A G E N D A

Architectural Review Board

August 28, 2018

LAND USE DIVISION

1604 Gilmer Avenue

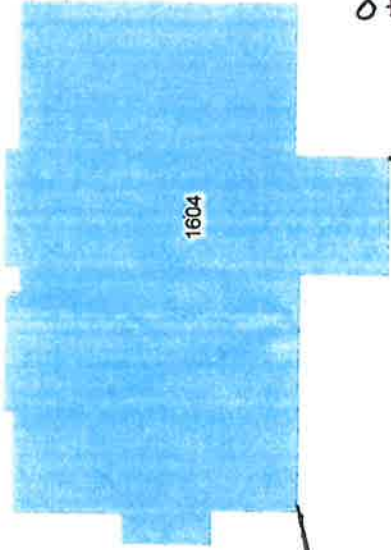
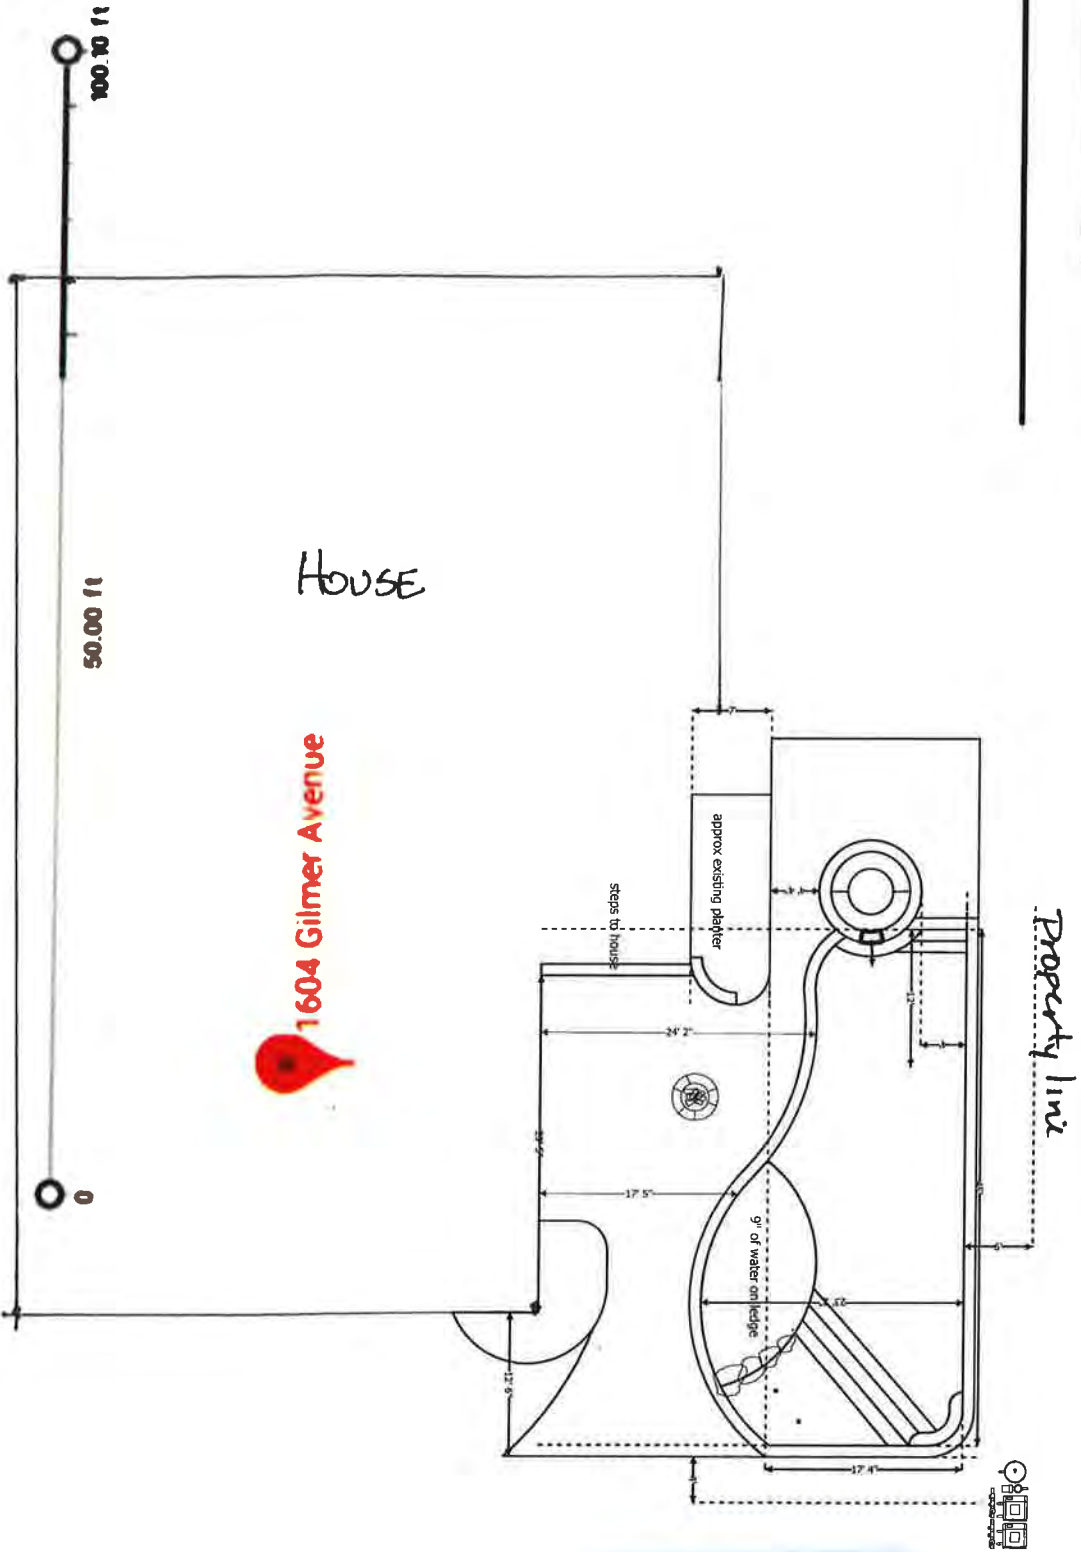
REMARKS: The petitioner is requesting permission to install an in-ground gunite pool in the interior side yard (corner lot) of the property. The pool is approximately 45' x17.5', located 6' from the existing property/fence line. A row of ornamental trees and an iron fence make up the south property line. An ornamental 4' metal fence (see sample image for detail) is proposed between the house and south property line; and a matching fence will be installed between the house and outbuilding OR a removable pool fence will be installed at the perimeter of the pool. A 4' fence with lockable gate is required to meet the building code for pools.

- The Board has generally approved in ground pools when there has not been an impact on mature trees. The Urban Forester has looked at the trees on the property line and has no objection to the proposal.

1827 Ridge Avenue

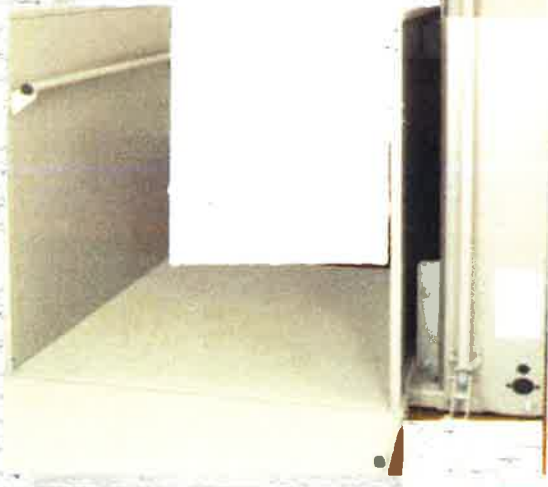
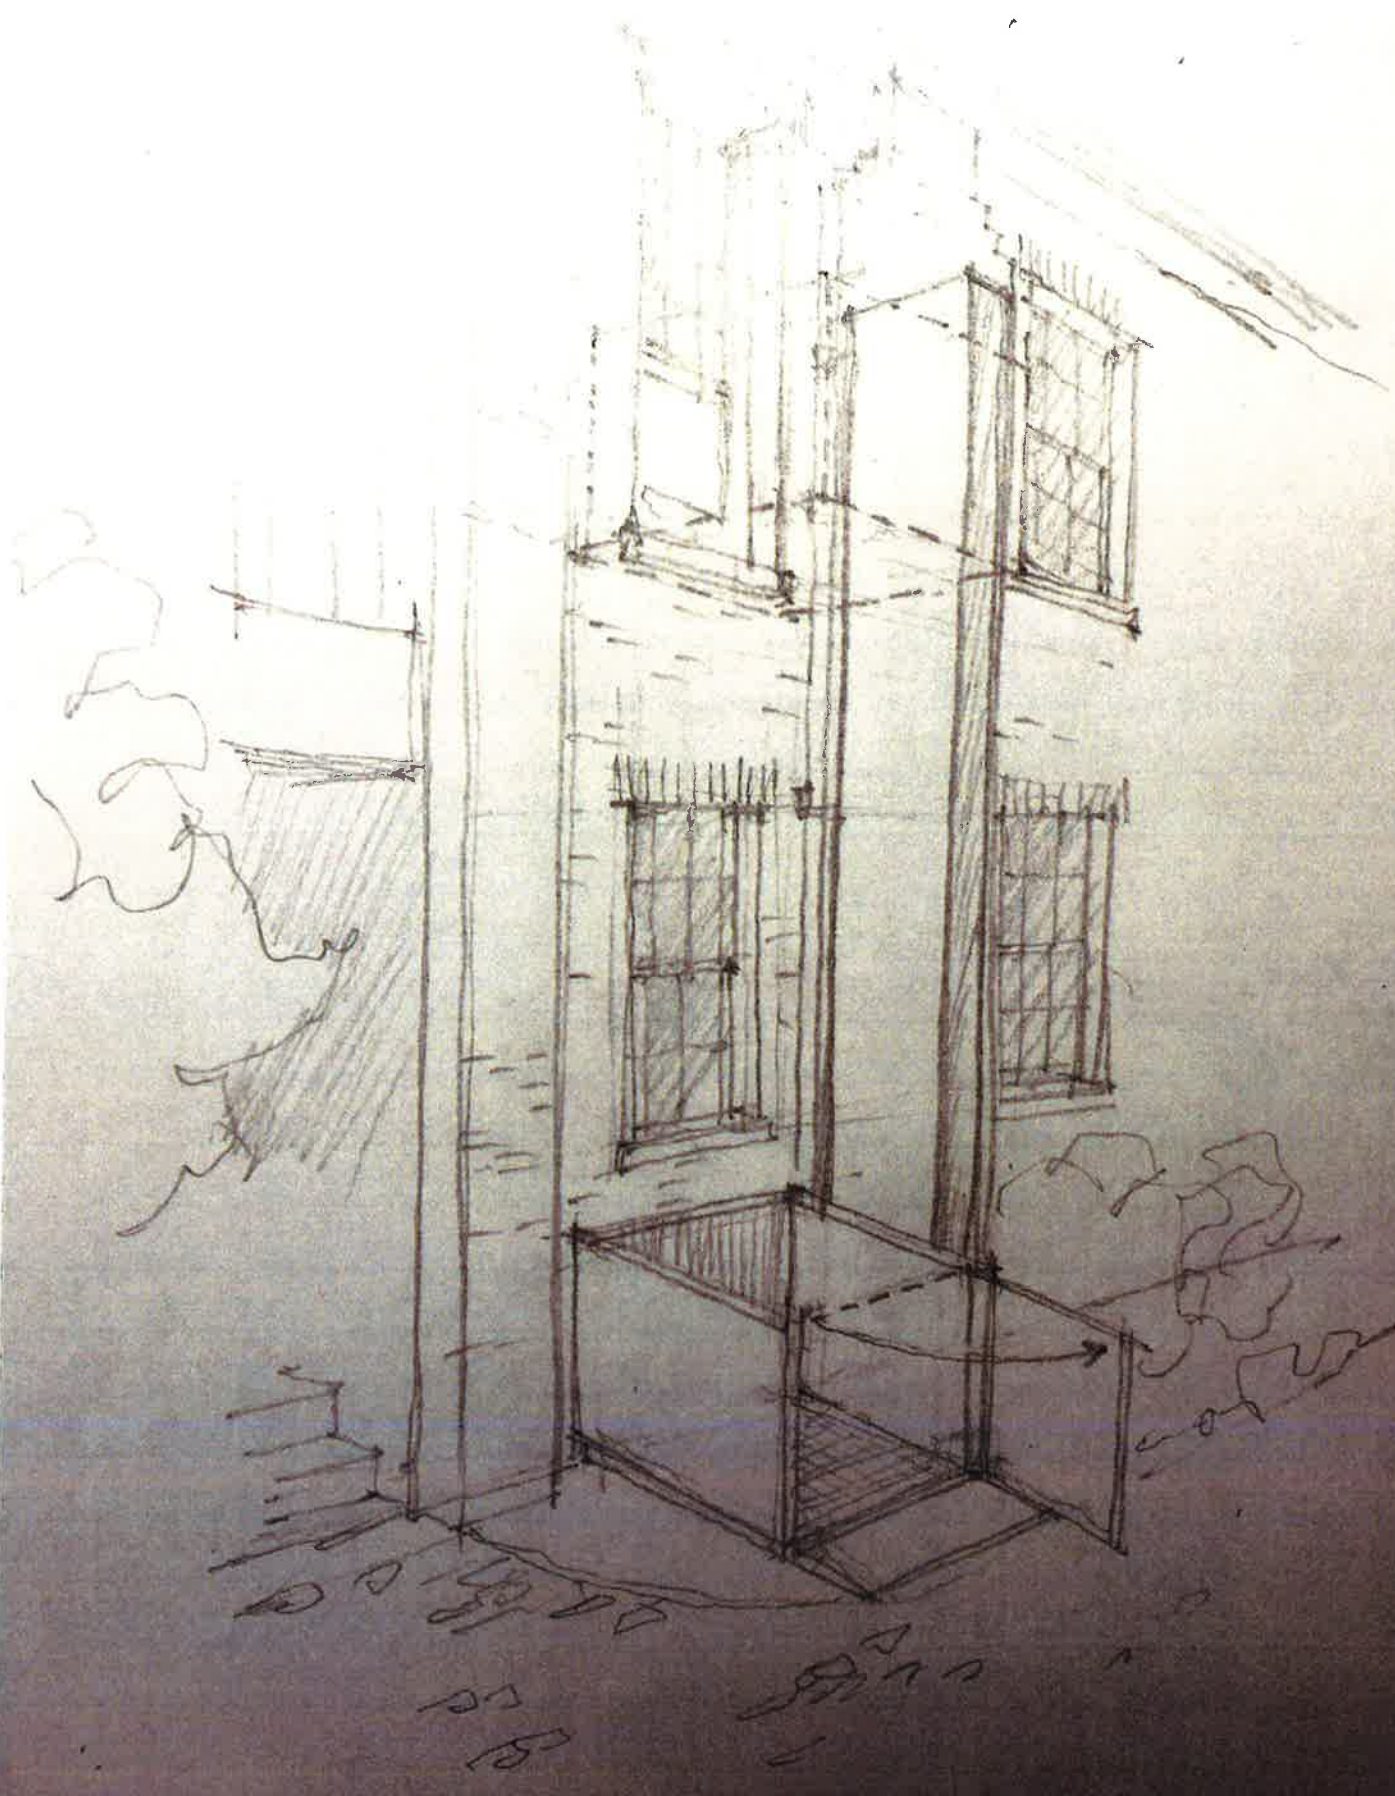
REMARKS: The petitioner is requesting permission to install a vertical platform lift on the south side of the rear quadrant of the building. The building is divided into condo units, and the petitioner explored installing an interior lift to their second floor unit, but the space would not accommodate one that would service a wheelchair that will be required to ensure continued mobility of one of the owners. To accommodate the lift, an existing window would be converted to a door. The owner intends to retain the window and reinstall it once the lift is no longer required for access to the upstairs unit. The lift would be installed between an exterior door and a chimney projection next to the driveway.

- As the lift attaches to the building and does not require the construction of a shaft, staff considers this to be a reversible change to the building. The location of it just beyond the midpoint of the building also reduces its visibility from the street.
